Addendum 51: Regulation No. 52

Revision 2 - Amendment 2

Supplement 7 to the 01 series of amendments - Date of entry into force: 13 November 2004

**UNIFORM PROVISIONS CONCERNING THE APPROVAL OF M2 AND M3 SMALL
CAPACITY VEHICLES WITH REGARD TO THEIR GENERAL CONSTRUCTION**

"Figure 15b

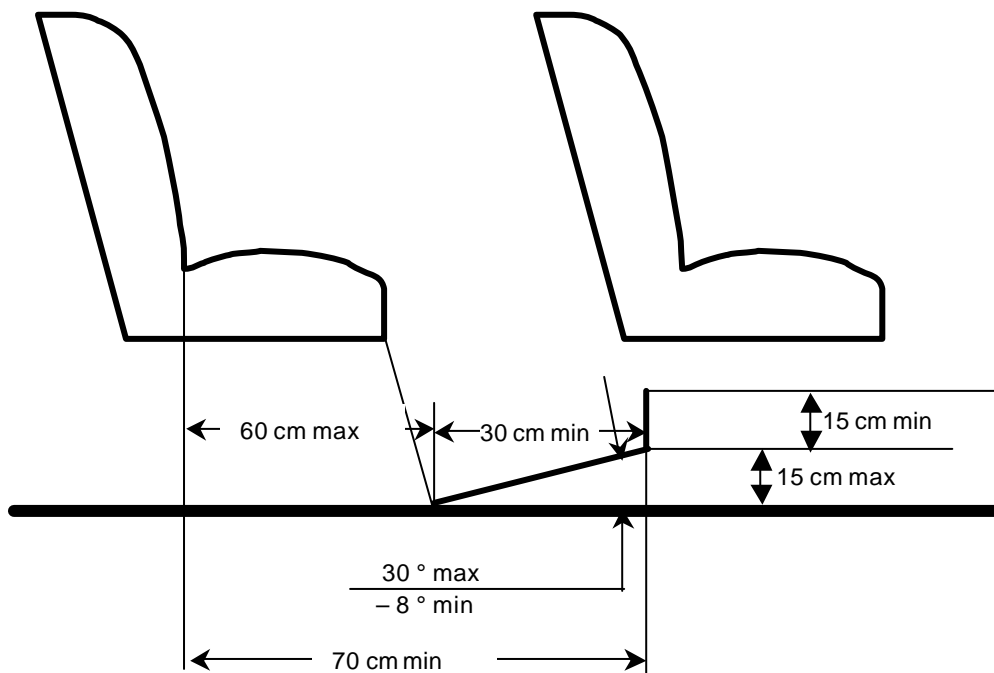
Insert a new figure 15b, to read:

SPACE FOR SEATED PASSENGERS BEHIND A SEAT AND/ OR A SEAT
FACING THE GANGWAY
(see paragraph 5.7.8.5.2.)

Insert a new paragraph 5.7.8.5.2., to read:

"5.7.8.5.2. For a seat behind a seat and/or a seat facing the gangway, a minimum clear foot space of at least 300 mm depth and a width according to paragraph 5.7.8.2.1. shall be provided as shown in annex 3, figure 15b. The local presence in this space of seat legs and of intrusions as provided by paragraphs 5.7.8.1.3.3. and 5.7.8.1.3.4. shall be permitted provided that adequate space remains for the passengers' feet. This foot space may partly be situated in and/or above the gangway but shall not create any obstruction when measuring the minimum gangway-width in accordance with paragraph 5.7.5. Intrusion of the seat belts and seat belt anchorages shall be allowed."

"Figure 21
ACCESS TO DRIVER'S DOOR
(See paragraph 5.6.2.5.2.)

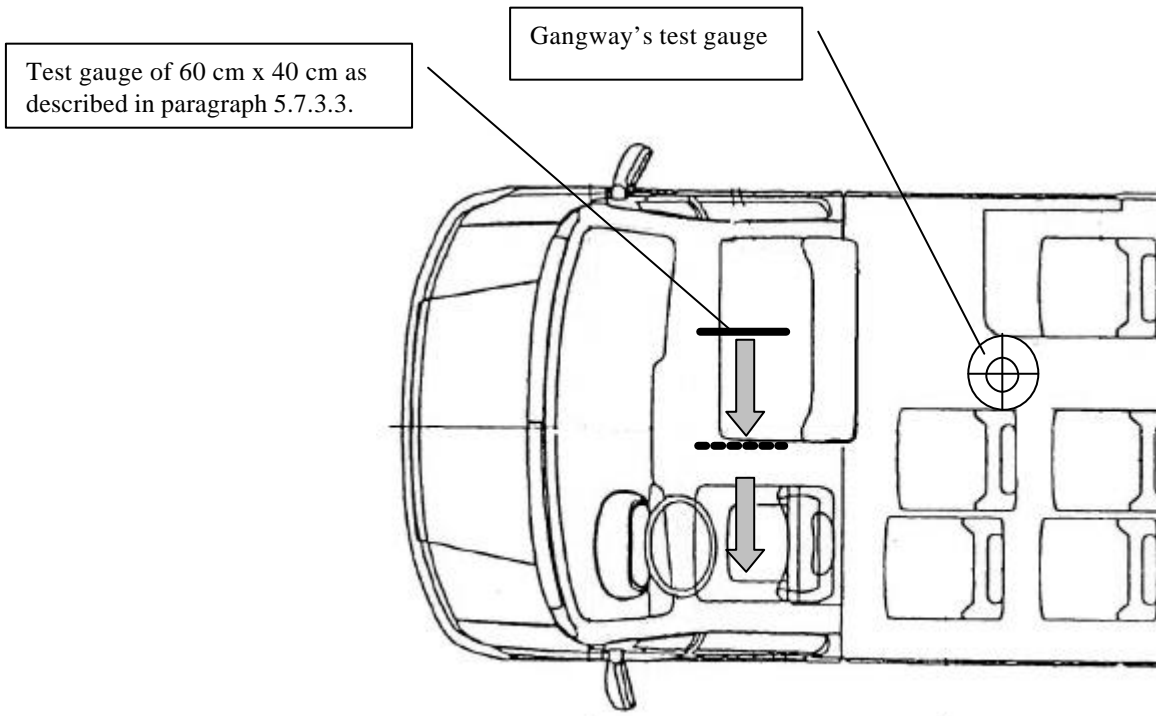
Insert new figures 21 and 22, to read:

Paragraph 5.6.2.5.2., amend to read (the reference to footnote 5/ and footnote 5/, should be deleted):

"5.6.2.5.2. The driver's door shall be accepted as the emergency door for the occupants of the seats situated beside the driver's seat provided that it is possible to move a test gauge from the occupants' seats to the exterior of the vehicle through the driver's door (see annex 3, figure 21).

Verification of the access to the driver's door shall be subject to the requirements of paragraph 5.7.3.2., by using the test gauge having a dimension of 600x400 mm, as described in paragraph 5.7.3.3. The service door provided for the passengers shall be in the side of the vehicle opposite to that containing the driver's door and shall be accepted as the emergency door for the driver;"

Figure 22

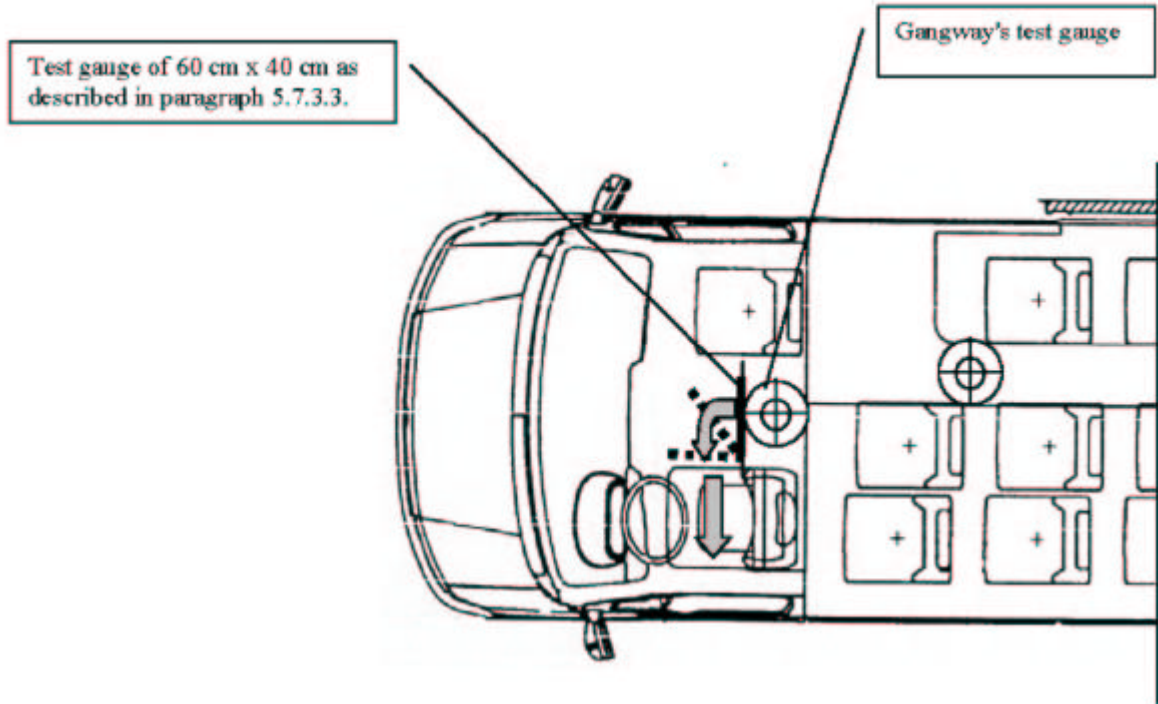
ACCESS TO DRIVER'S DOOR

(See paragraph 5.7.2.4.2.)

Paragraph 5.7.2.4.2., amend to read:

" indicated in paragraph 5.6.2.5.2 and that the space reserved for the driver's seat shall communicate with the main passengers' compartment through an appropriate passage; such requirement shall be deemed to be fulfilled if the test gauge described in paragraph 5.7.5.1. can move unobstructed from the gangway, until the front end of the gauge reaches the vertical plane tangential to the foremost point of the driver's seat back (this seat situated in its rearmost longitudinal position) and, from this plane, the panel described in paragraph 5.6.2.5.2. could be moved to the emergency door in the direction established by such paragraph (see annex 3, figure 22) with seat and steering wheel adjustment in their mid position."
